SERVICE BULLETIN

ENGINE — HIGH PRESSURE (HP) COMPRESSOR CASES — SIMPLIFIED
REAR INNER AND OUTER CASES

V2500 Series 72-0627

72-41-00

HIGH PRESSURE (HP) COMPRESSOR REAR OUTER AND REAR INNER CASES
FIGURE 1, SHEET 1

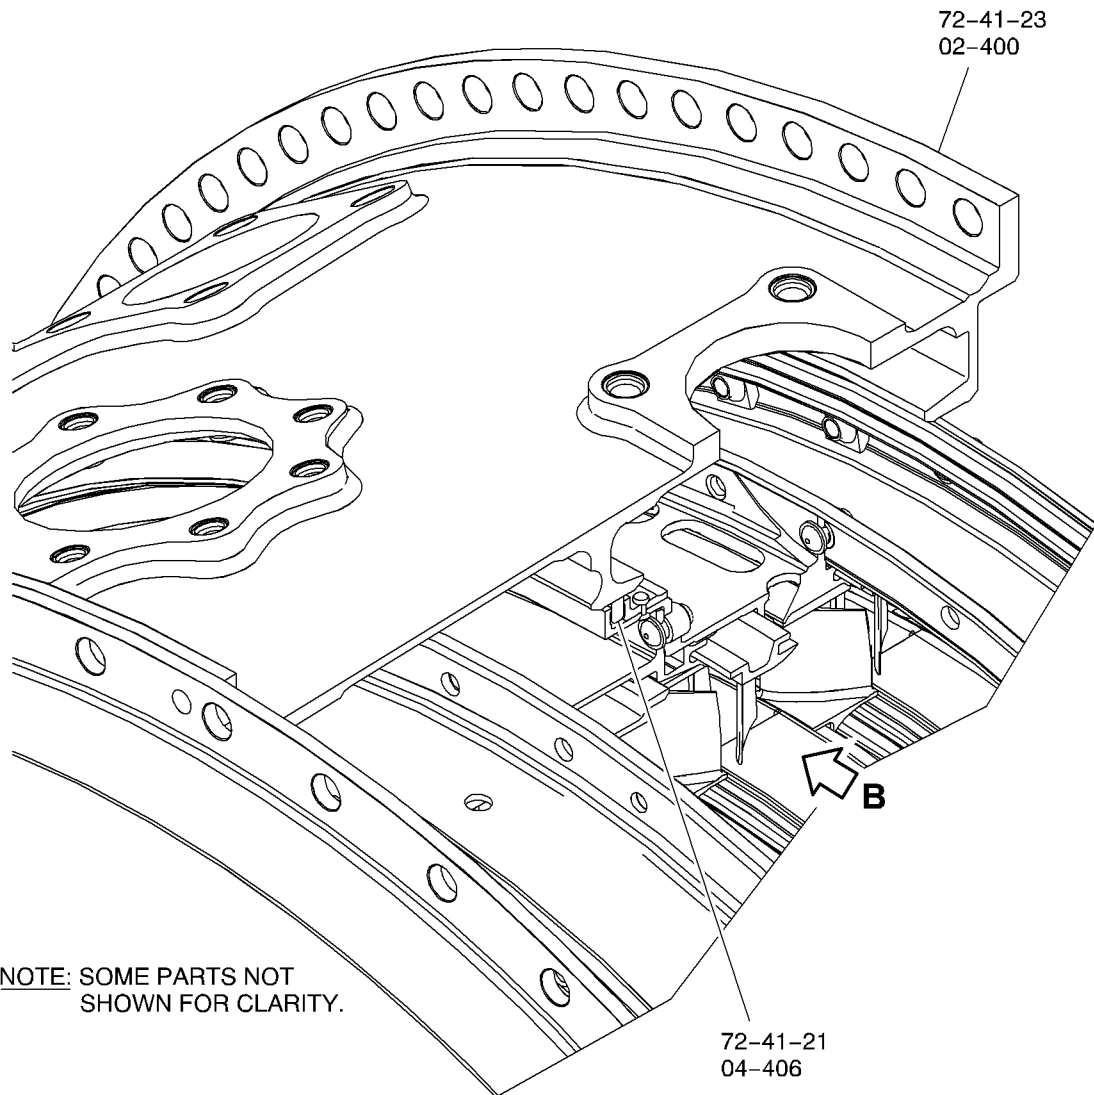
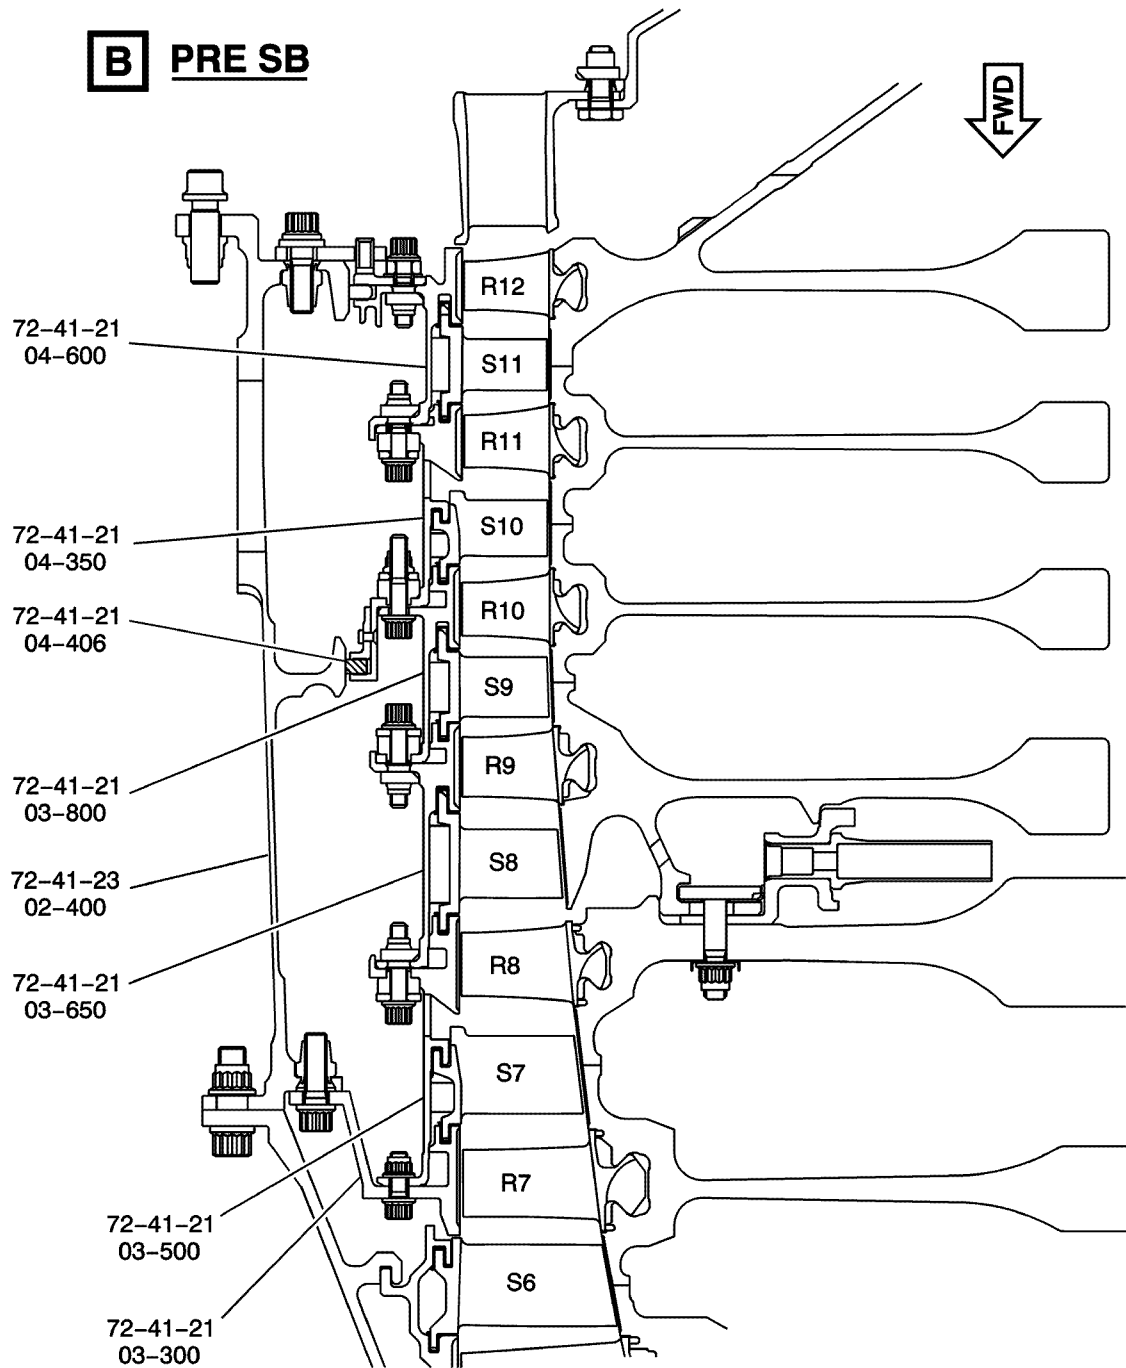
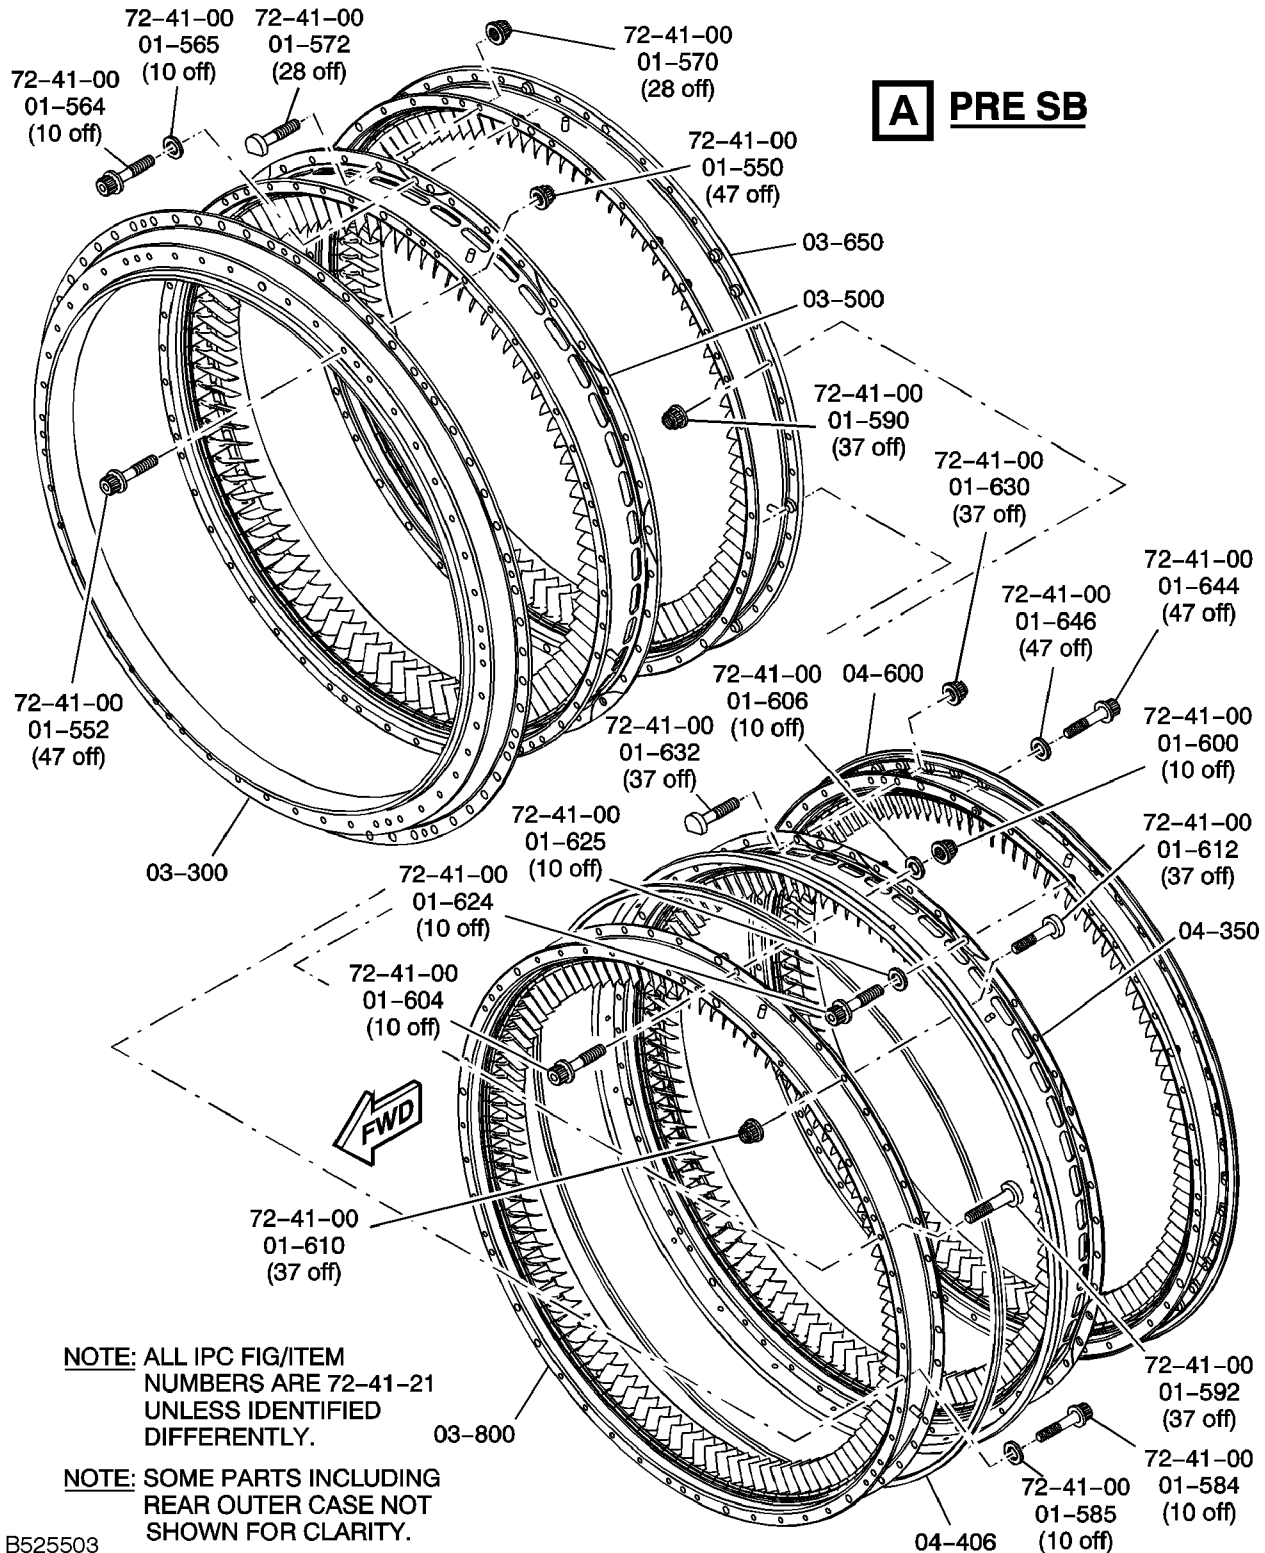
- D. Remove the HP compressor assembly (Refer to the Engine Manual, Chapter 72-00-41).
 - E. Disassemble the HP compressor assembly (Refer to the Engine Manual, Chapter 72-41-00 and to Figure 1)

- (1) Remove the old HP compressor rear outer case assembly (72-41-23, 02-400), PN 6A8162.
 - (2) Remove the cross key location ring (72-41-21, 04-750).

HIGH PRESSURE (HP) COMPRESSOR REAR OUTER AND REAR INNER CASES
FIGURE 2, SHEET 1

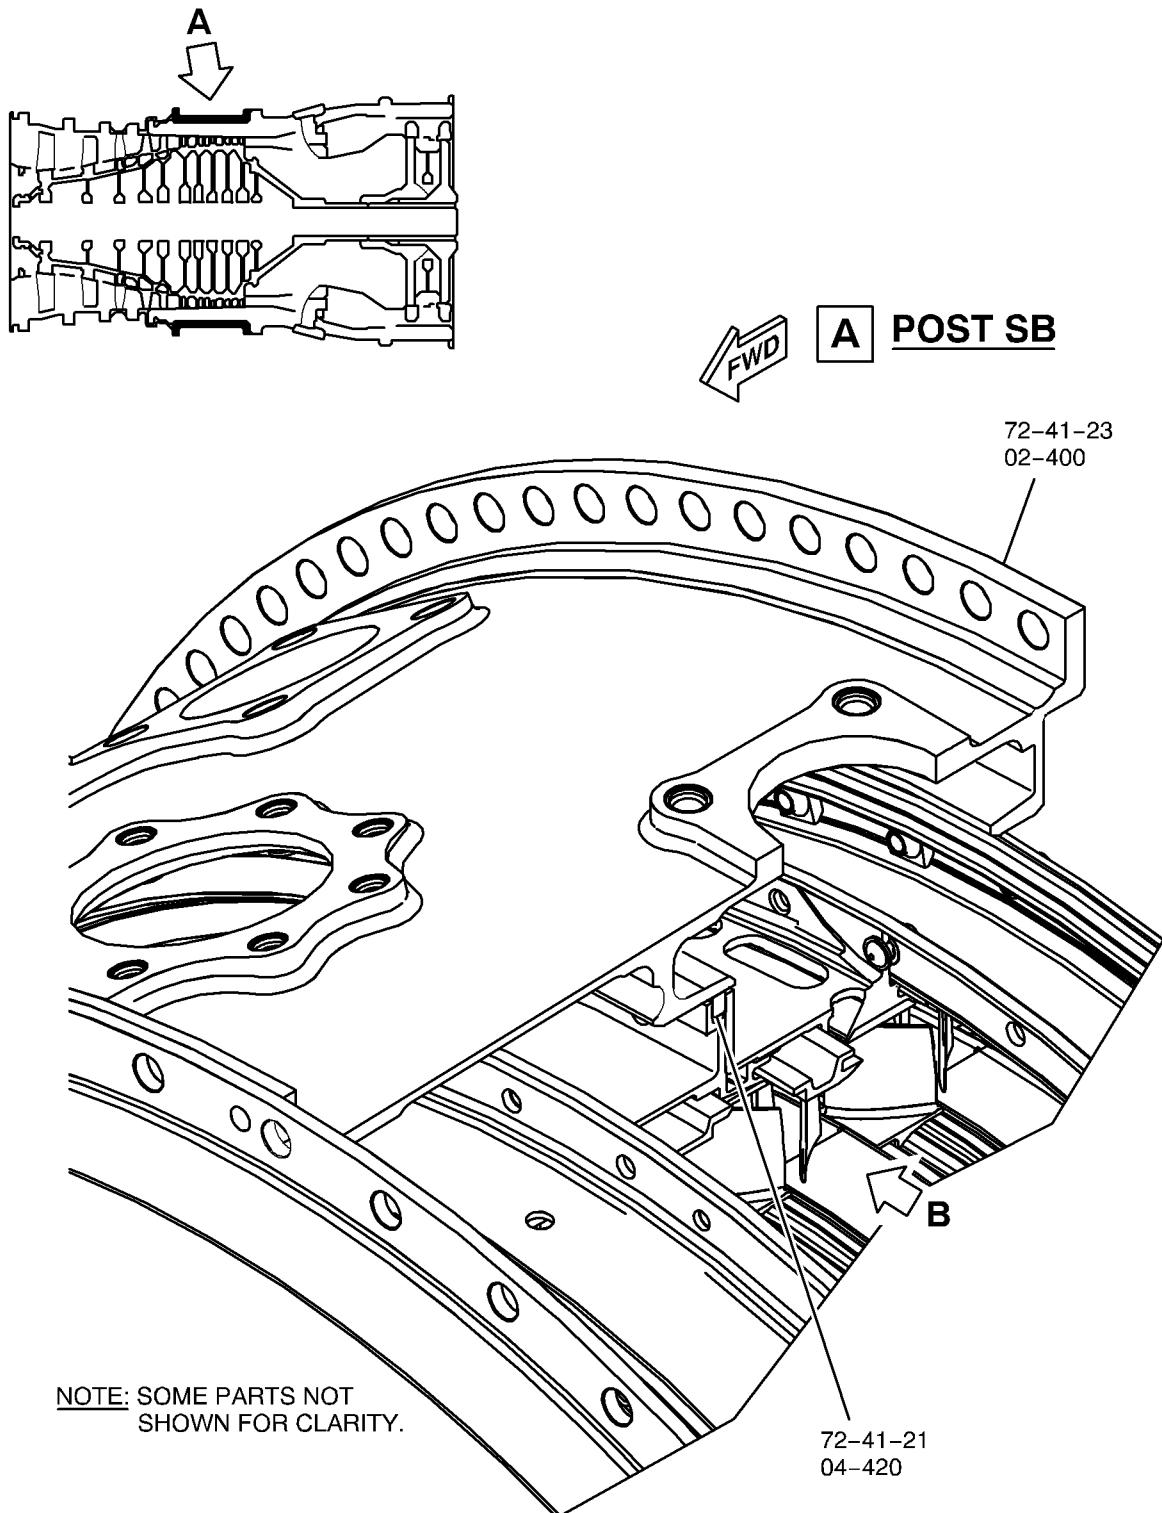
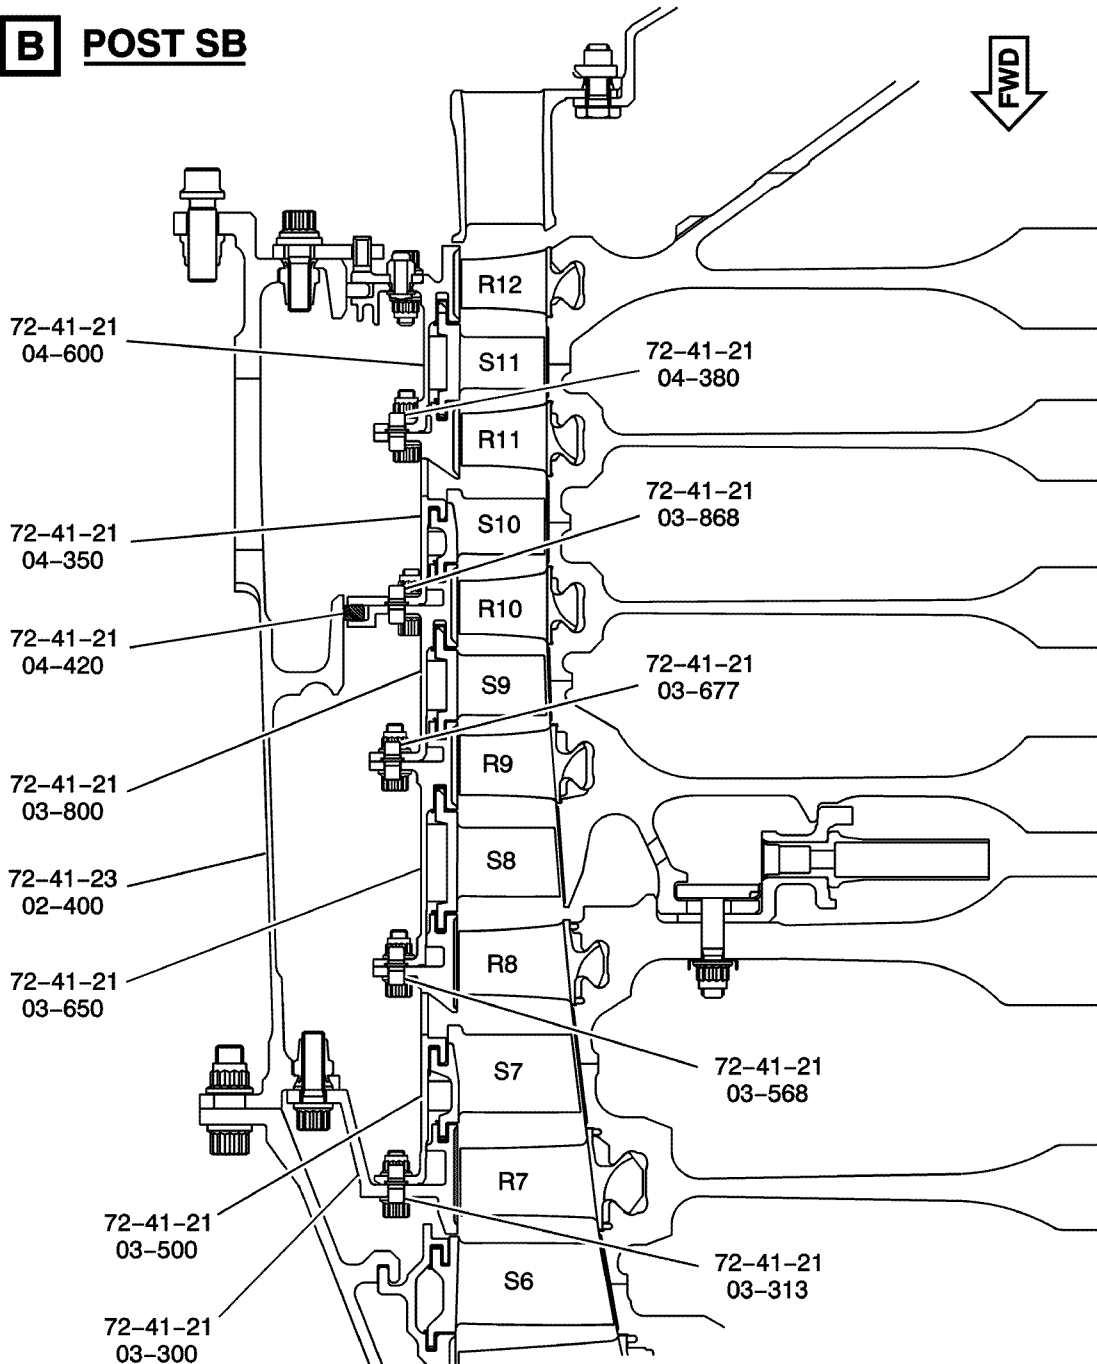
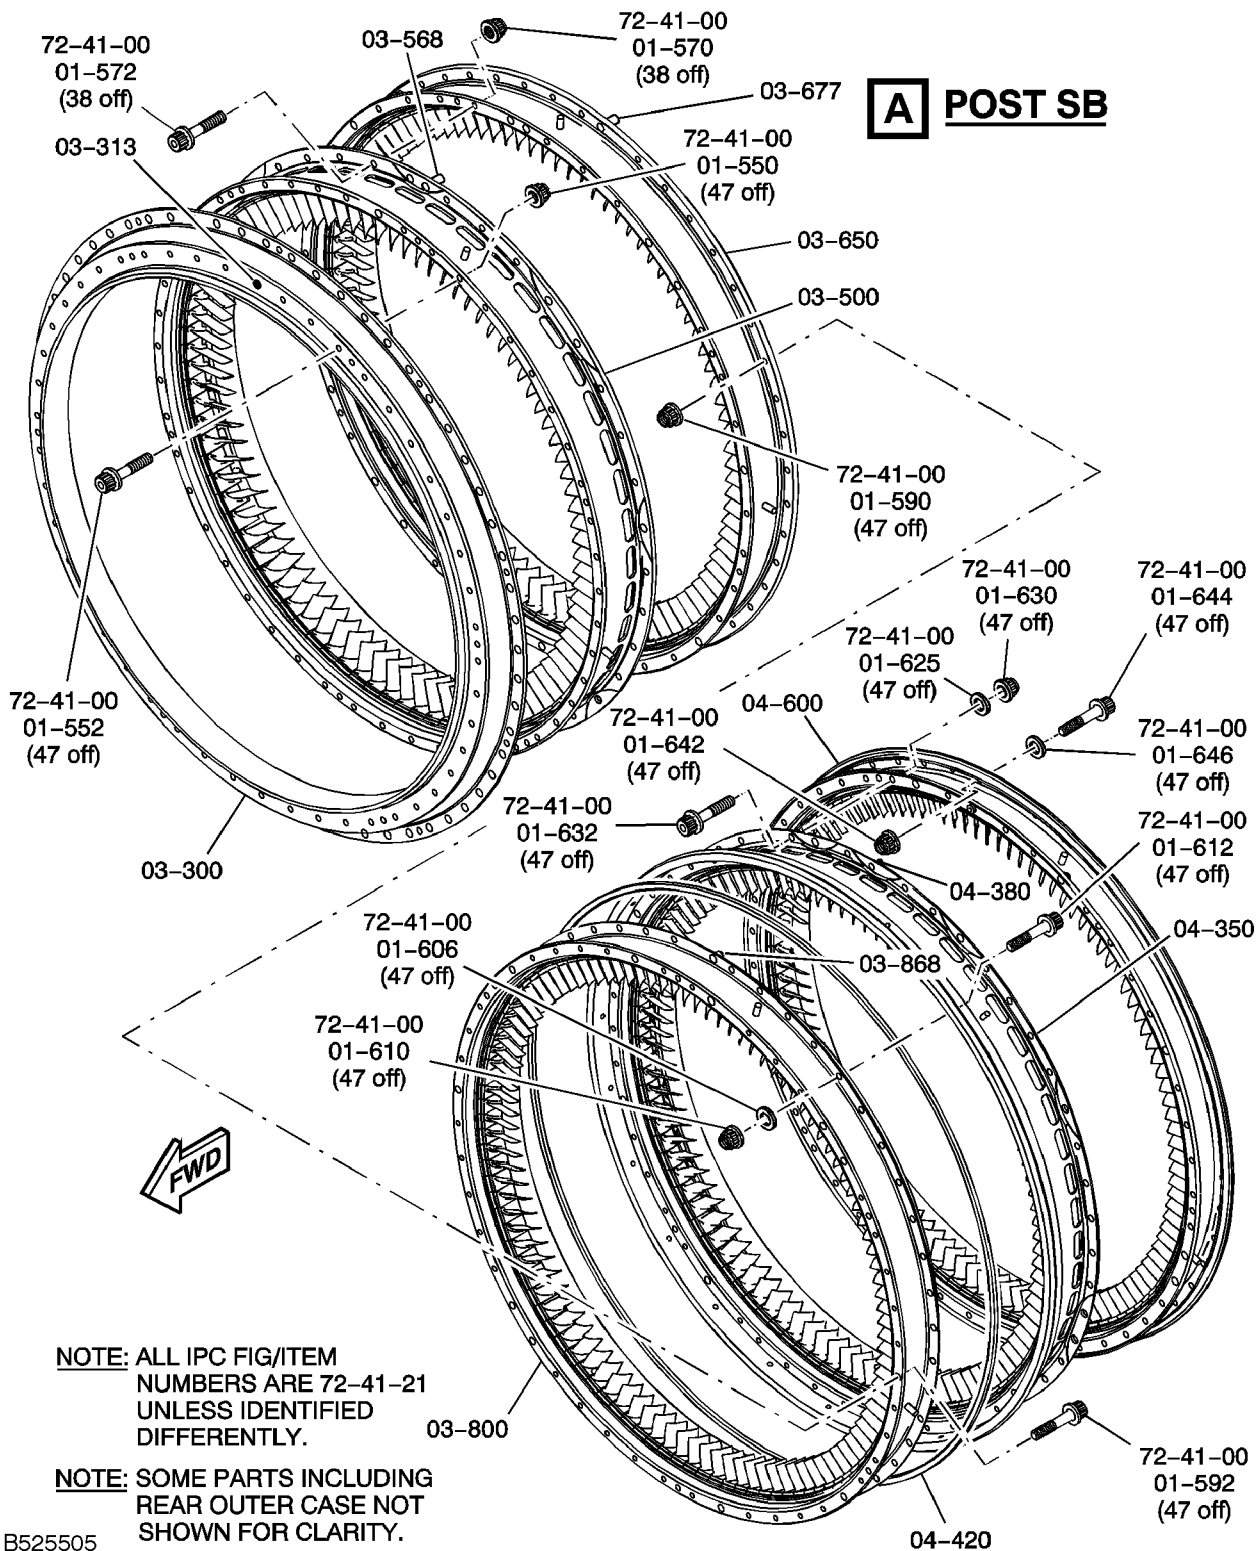
- (8) Remove the old HP compressor Stage 7 rotor path case assembly (72-41-21, 03-300), PN 6A7577.
- F. Assemble the HP compressor rear cases and vanes on to the HP compressor rotor assembly (Refer to the Engine Manual, Chapter 72-41-00 and to Figure 2).
